Addendum 01

PROJECT: Zane Grey Intermediate School MVHC Clinic Renovation
968 Pine Street
Zanesville, Ohio 43701

PROJECT #: 25006.02

This addendum form is a part of the Contract Documents and modifies the Bidding Documents titled "Construction Documents," dated June 17, 2025, with amendments and additions noted below.

A6.1

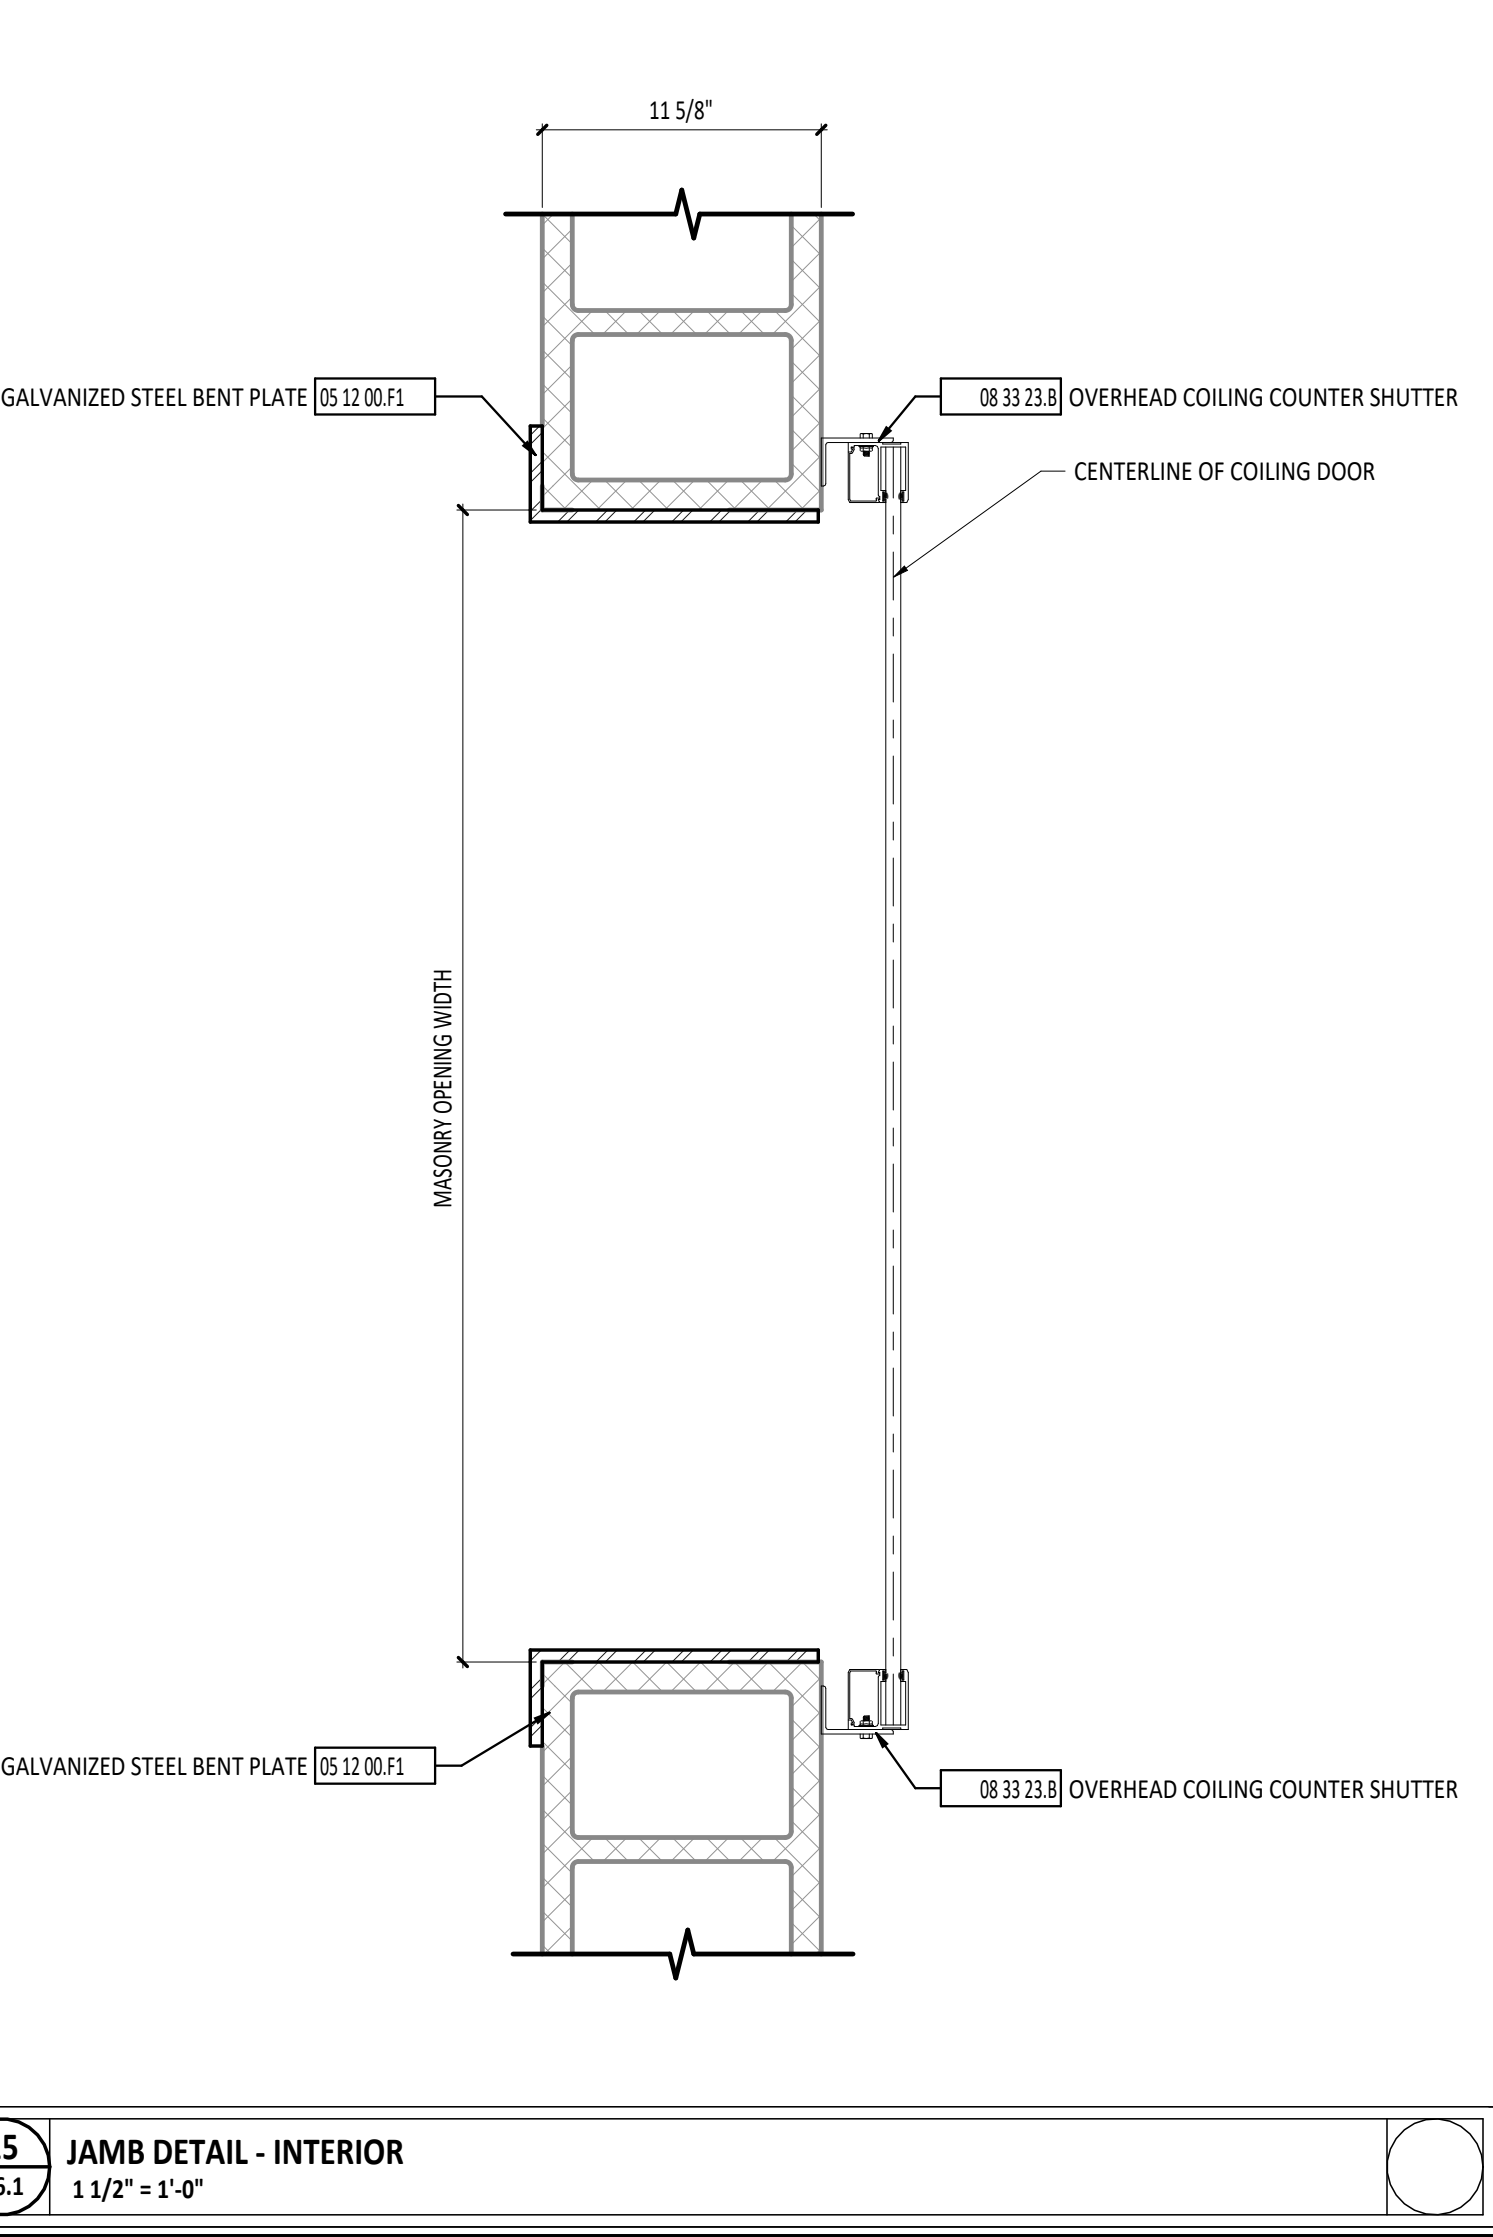
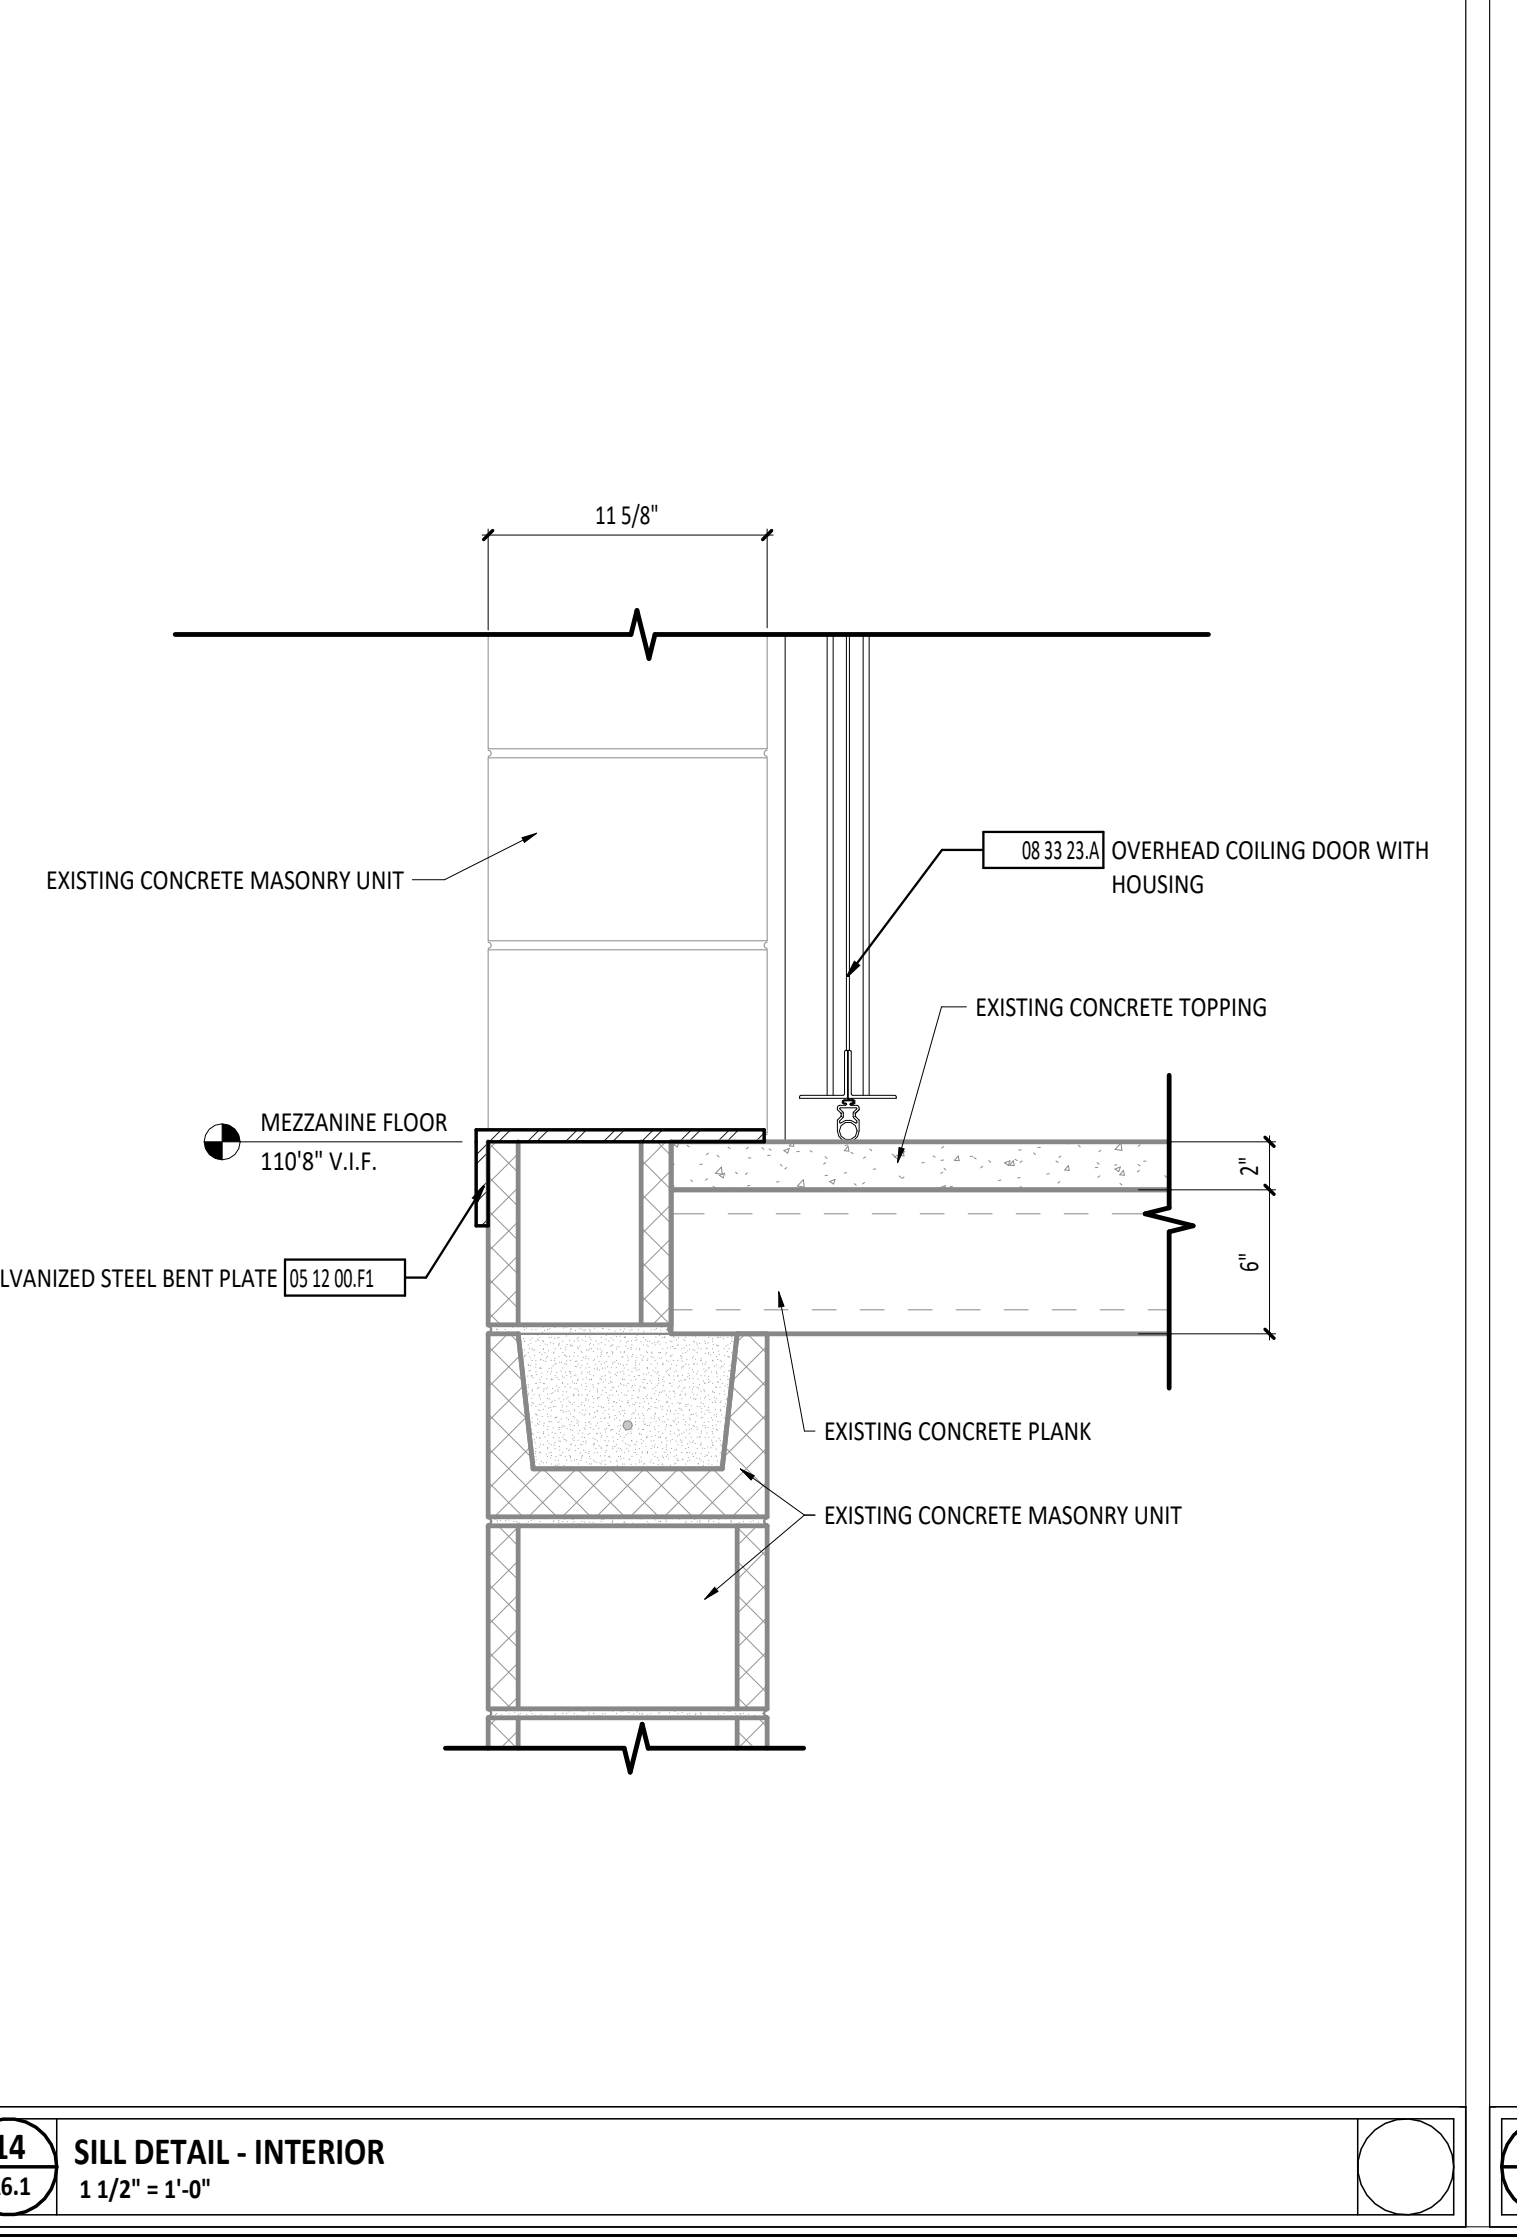
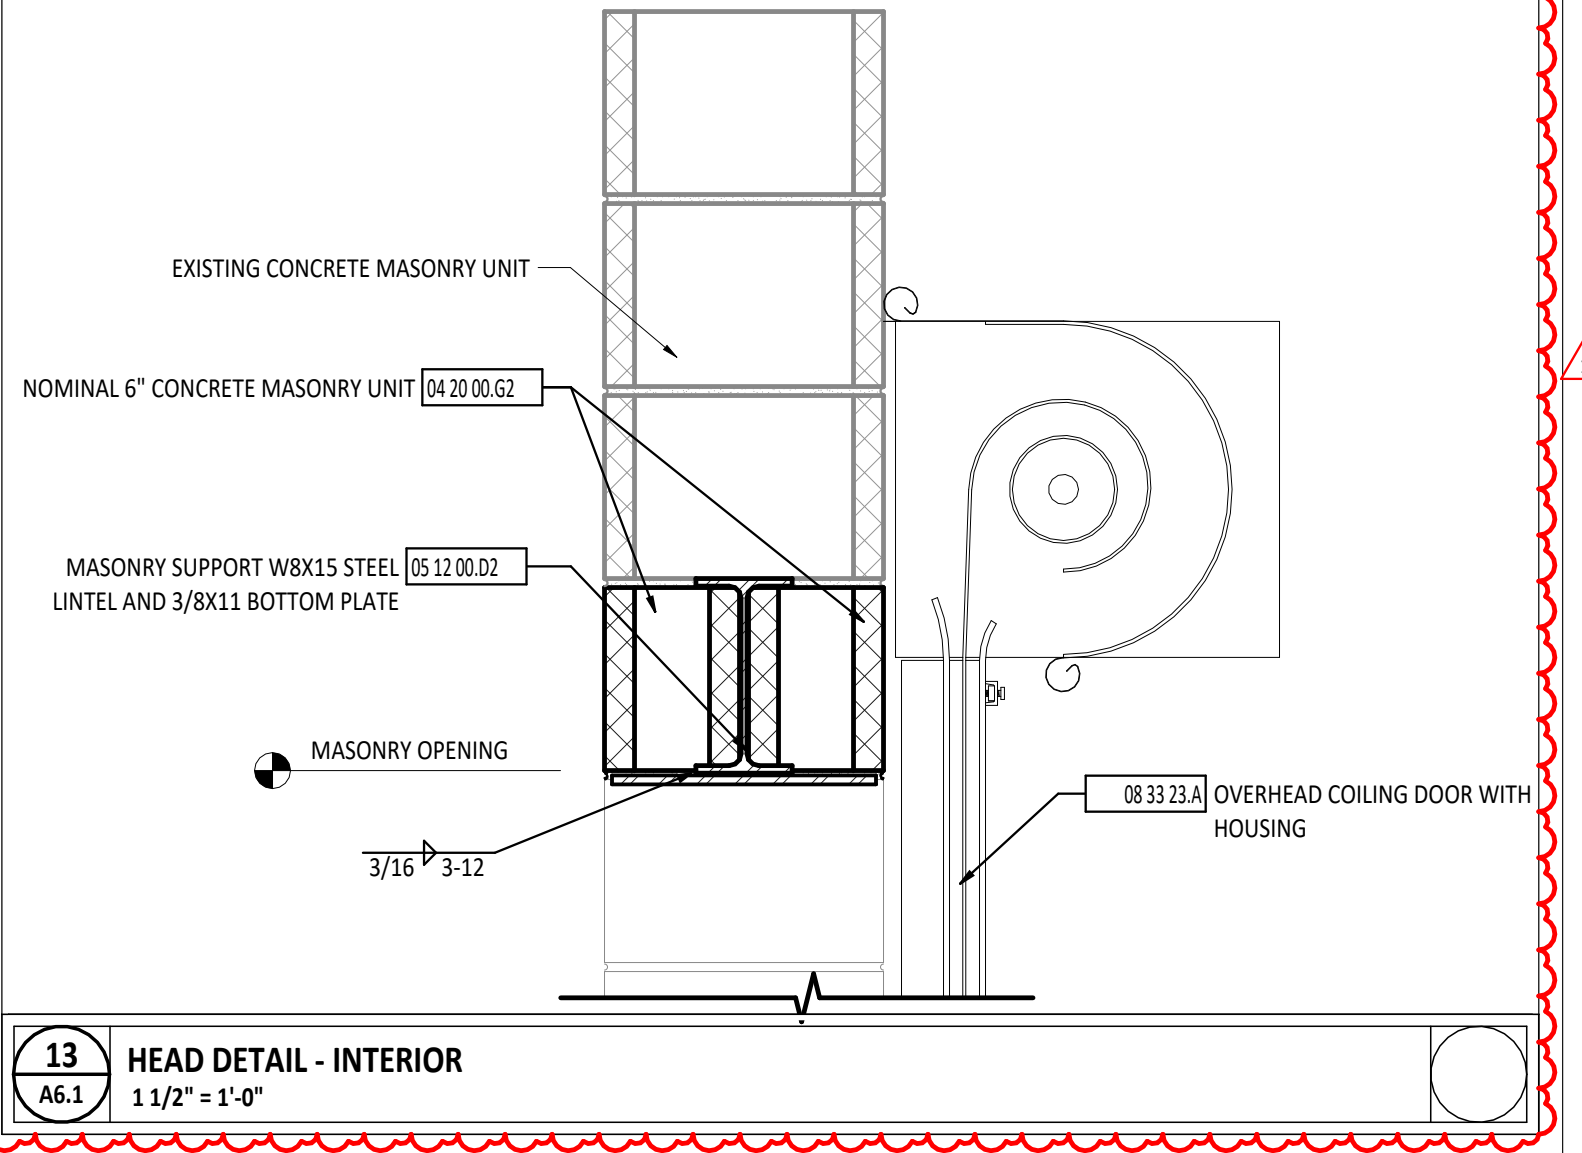
1. Drawing Sheet A6.1 Door Schedule & Door Details:
 - a. Add hardware sets to door schedule.
 - b. Revise detail 13/A6.1 to include structural steel lintel and plate.
